CROW BUTTE RESOURCES, INC.

Re: ~~Docket No. 40-89437~~
License No. SUA-1534
Annual Report of Changes, Tests, or Experiments

2003 SERP Evaluation Index

2003 SERP Actions

Figure 3.2-1: General Arrangement- Main Processing Facility

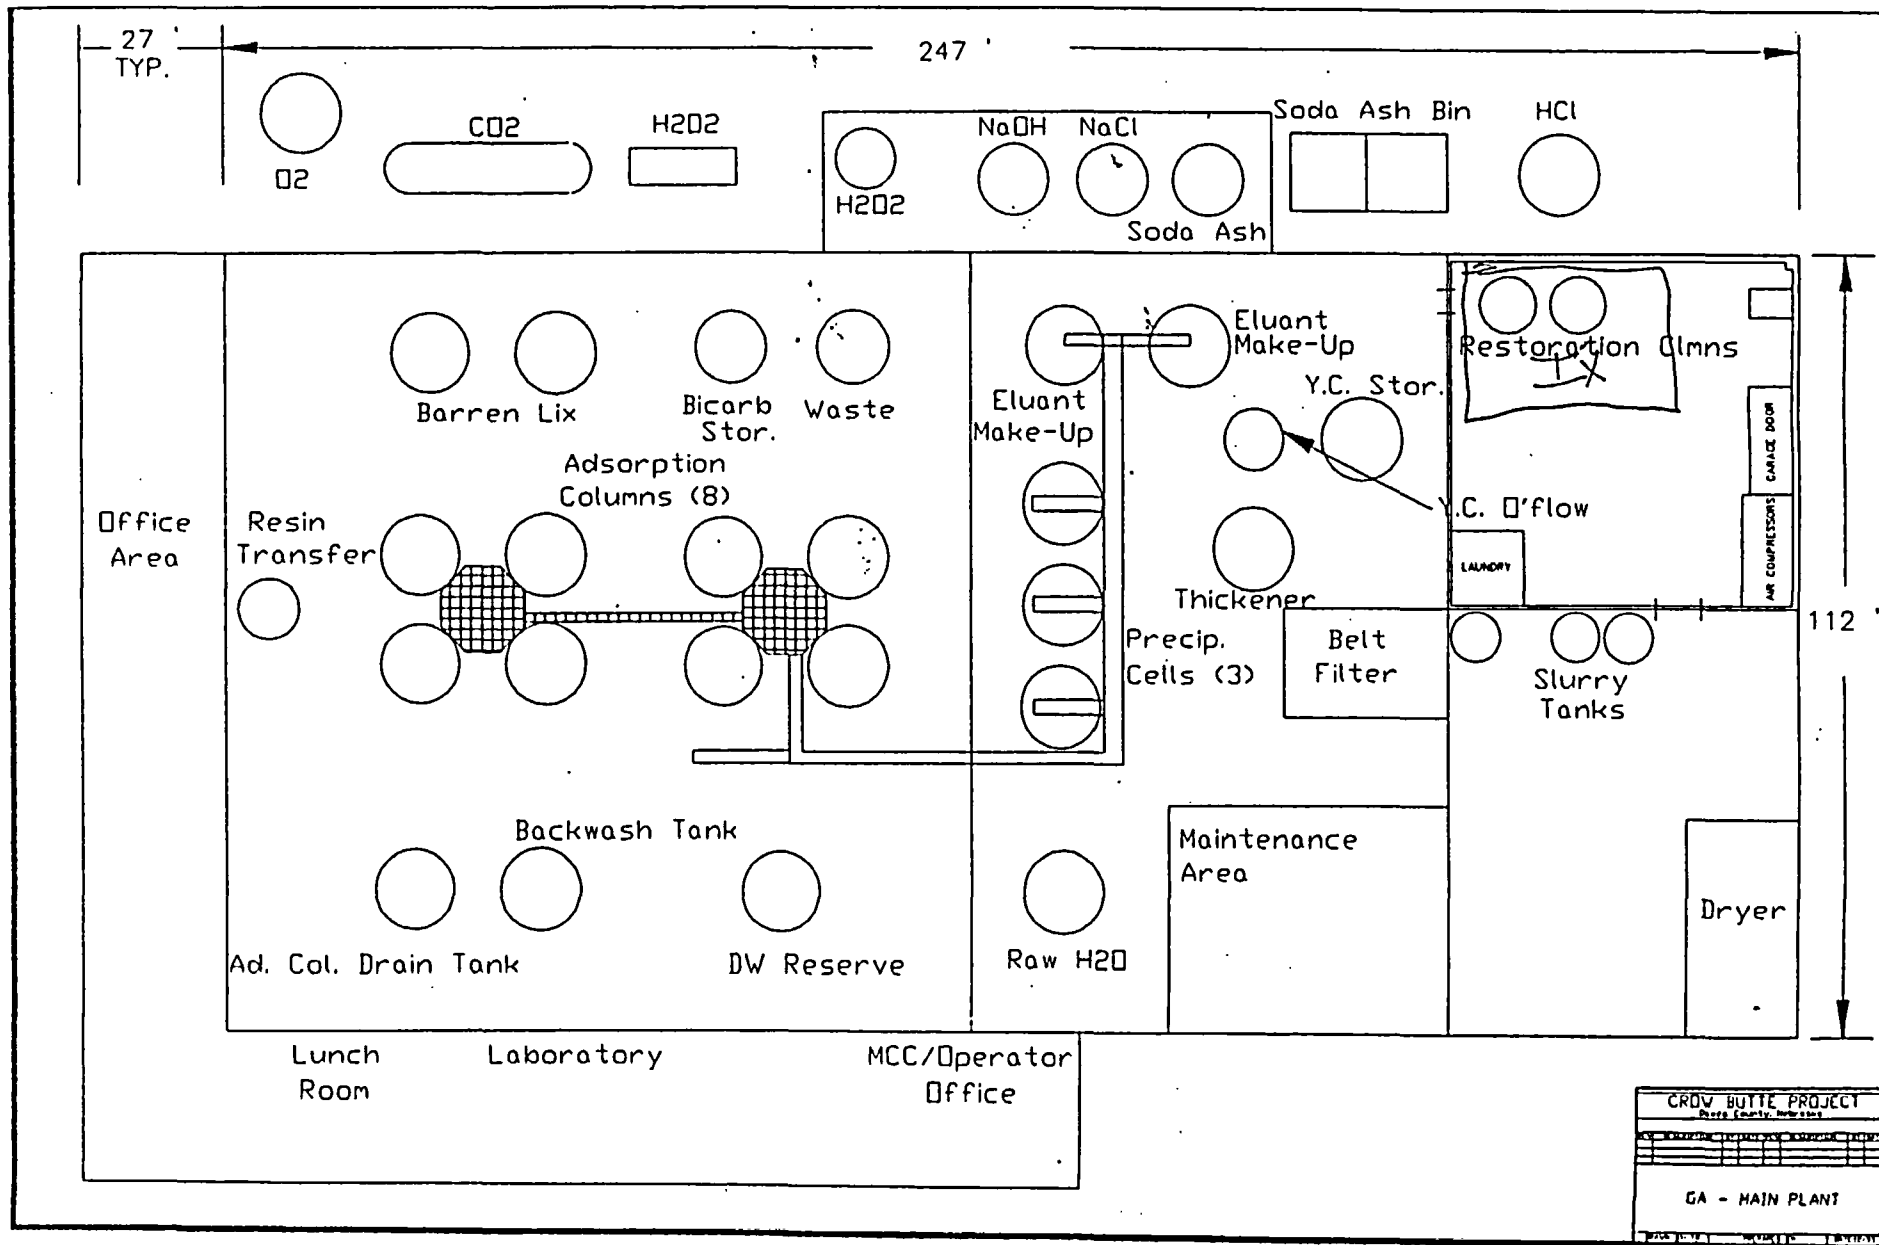
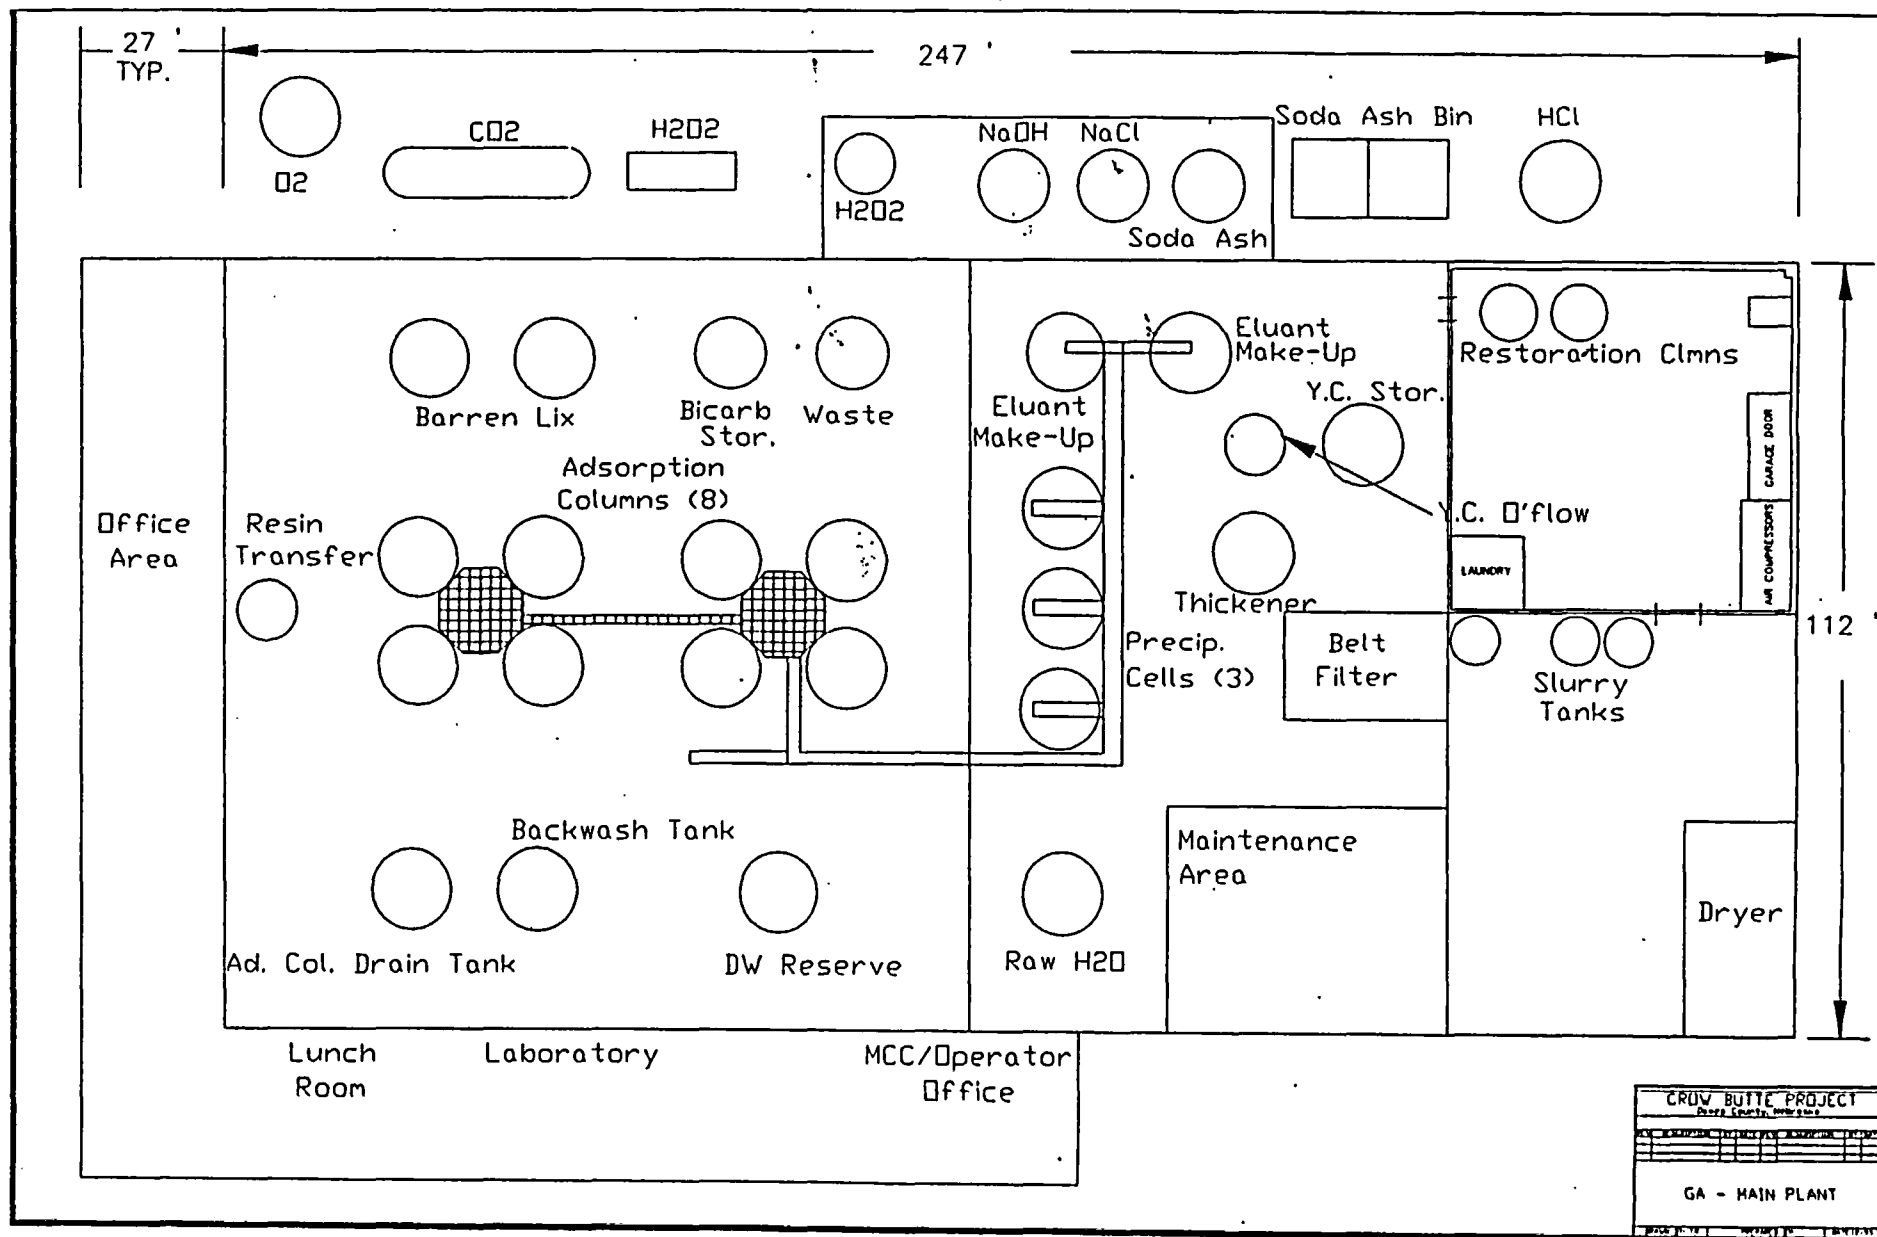
Generalized process figures 3.1-6, 3.2-1 and 6.1-1 from the License Renewal Application were reviewed as part of the SERP. The SERP determined that the schematics were too specific regarding the number and labeling of restoration IX columns as well as the source of fluids. The existing and revised figures are attached so side-by-side comparisons can be made.

Figure 5.1-1: Crow Butte Resources Organizational Chart

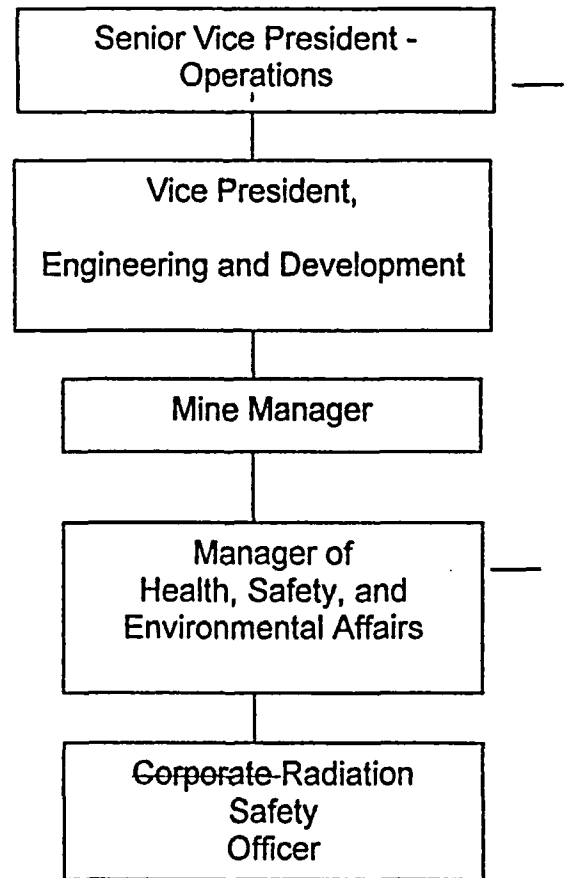
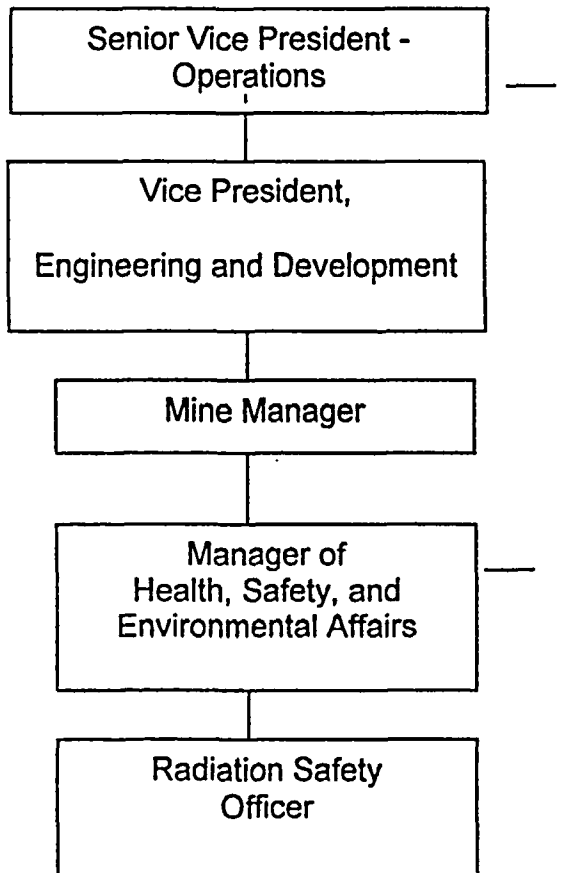
The purpose of the SERP evaluation was to review a proposed change affecting the title of a member of the radiation safety staff. Specifically, it is proposed that the title of the Corporate Radiation Safety Officer (CRSO) be changed to Radiation Safety Officer (RSO). There are no changes proposed to the duties and responsibilities of the RSO as defined in the CBR License Renewal Application (LRA).
